GOVERNMENT OF THE DISTRICT OF COLUMBIA
DEPARTMENT OF TRANSPORTATION

MEMORANDUM

DATE: October 14, 2016

SUBJECT: ZC Case No. 16-07 – 810 O Street, NW

Figure 1: Site Design and Access (Source: Gorove/Slade)

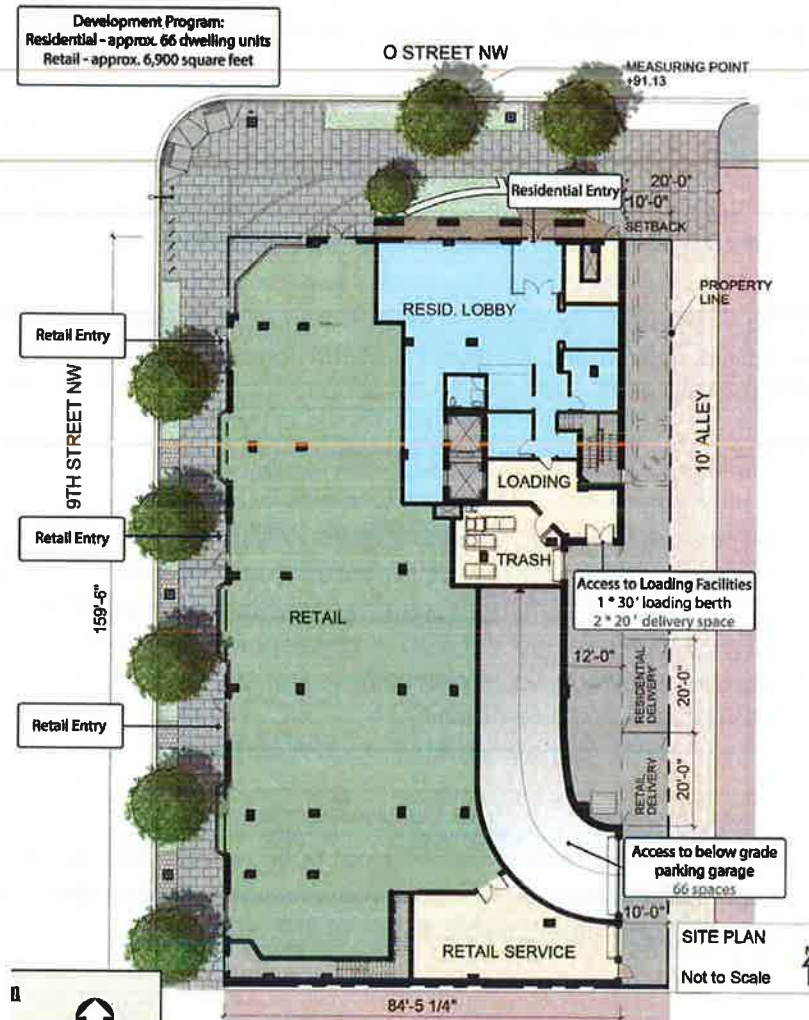
- The existing 10-foot public alley adjacent to the site is proposed to be widened to 20-feet along the site in order to enable front-in and front-out loading and vehicle parking, which meets DDOT standards; and
- The amount of the loading facilities is appropriate.

The proposed project is located adjacent to an existing 10 foot public alley to the east of the site, and the Applicant proposes to widen the alley by 10 feet to 20 feet immediately along their site. Vehicular, loading, and bicycle access is proposed via this public alley.
